Robert E. Moran, PhD.
Hydrogeology / Geochemistry
Michael-Moran Assoc., LLC
Colorado, U.S.A.
remwater@gmail.com

Dewey-Burdock Project

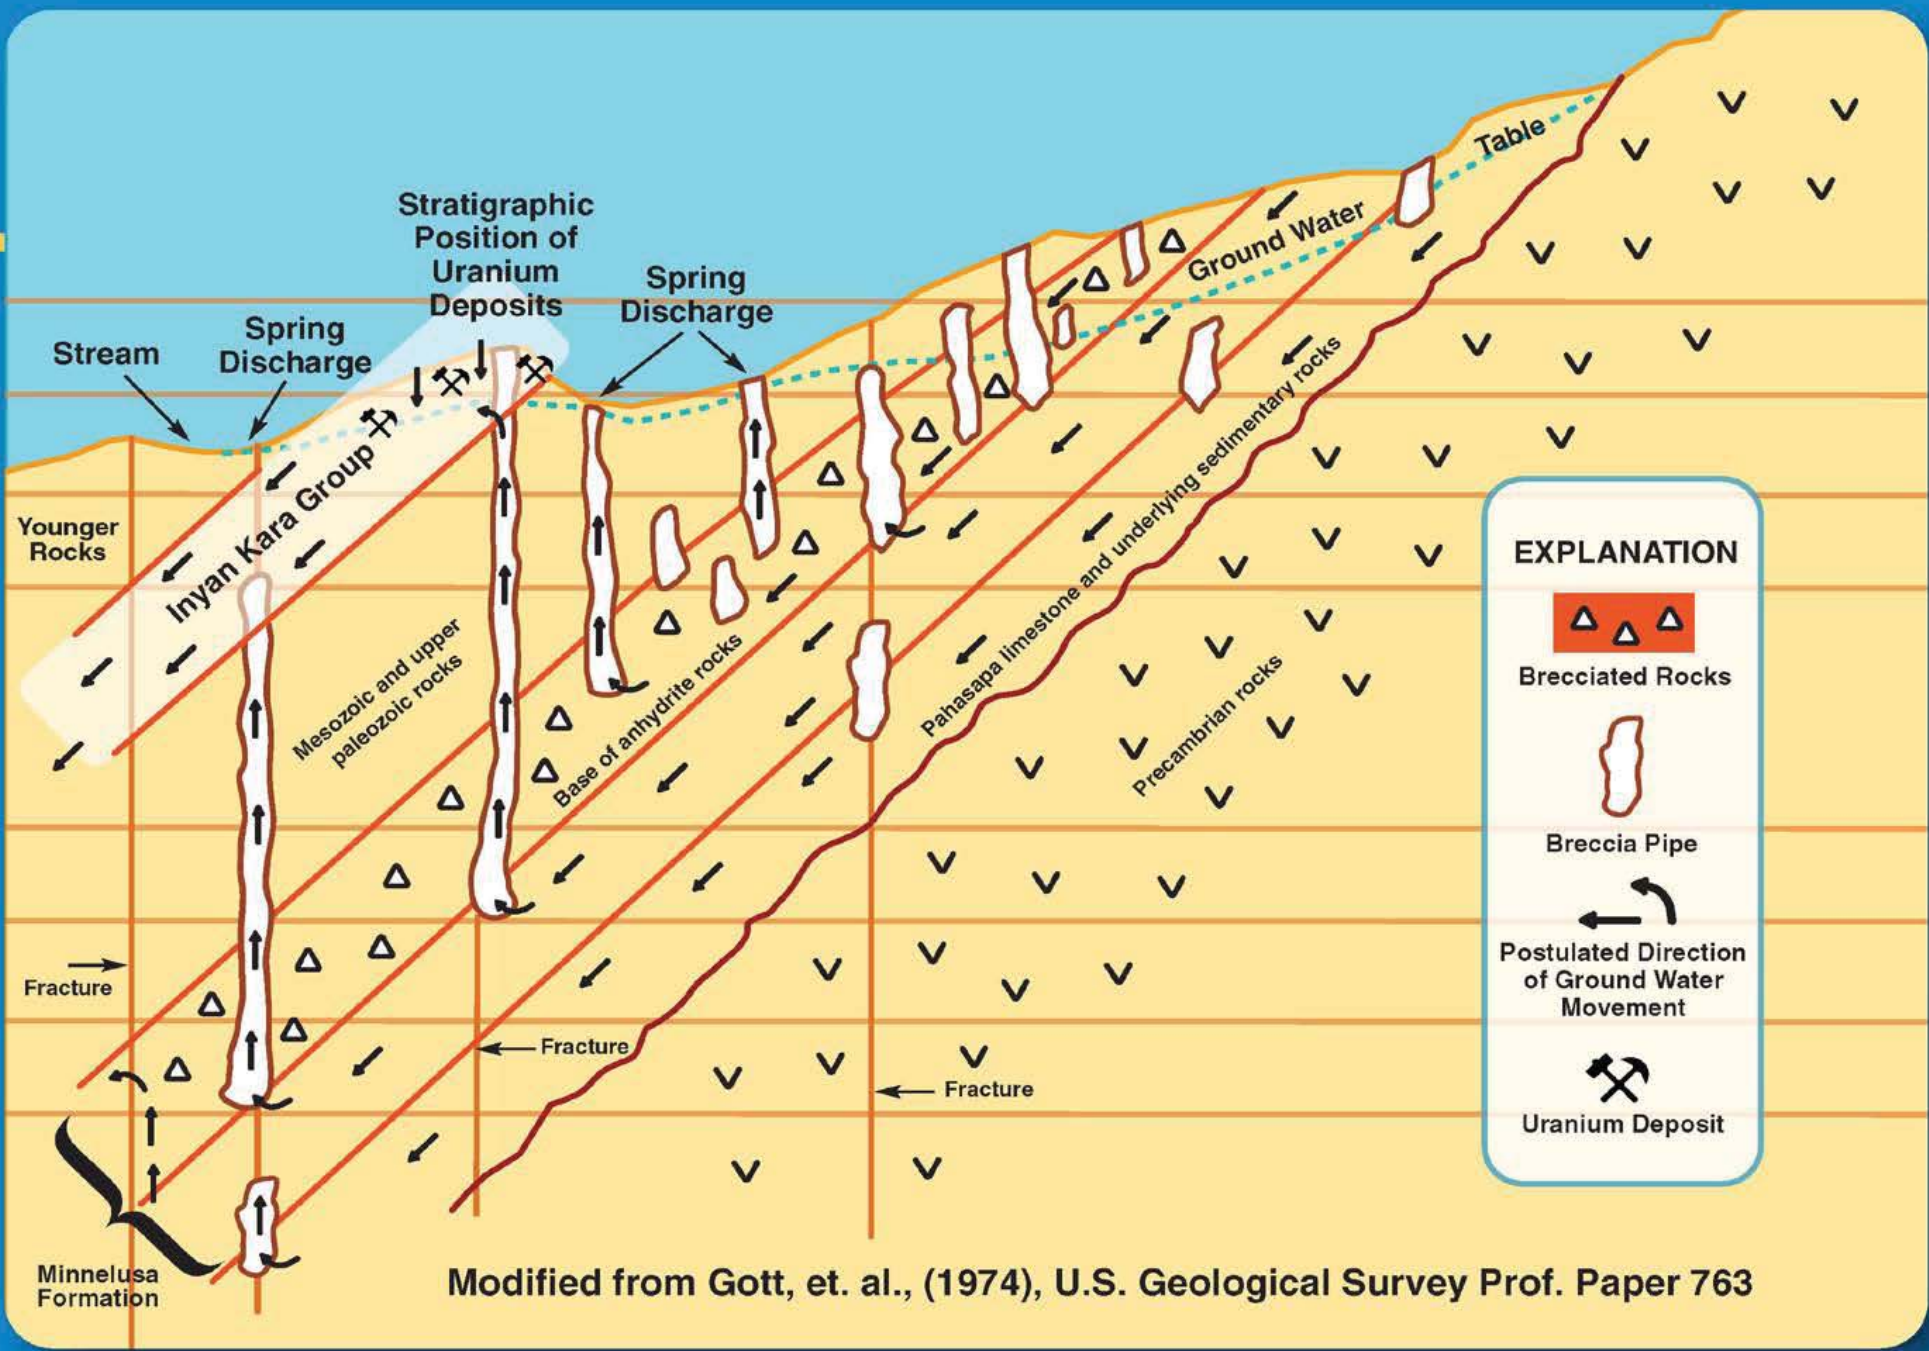
All DB water-bearing zones

Hydrogeologically-interconnected

★ inter-fingering sediments

★ fractures

★ faults

★ breccia pipes

★ 4,000 to 6,000 boreholes
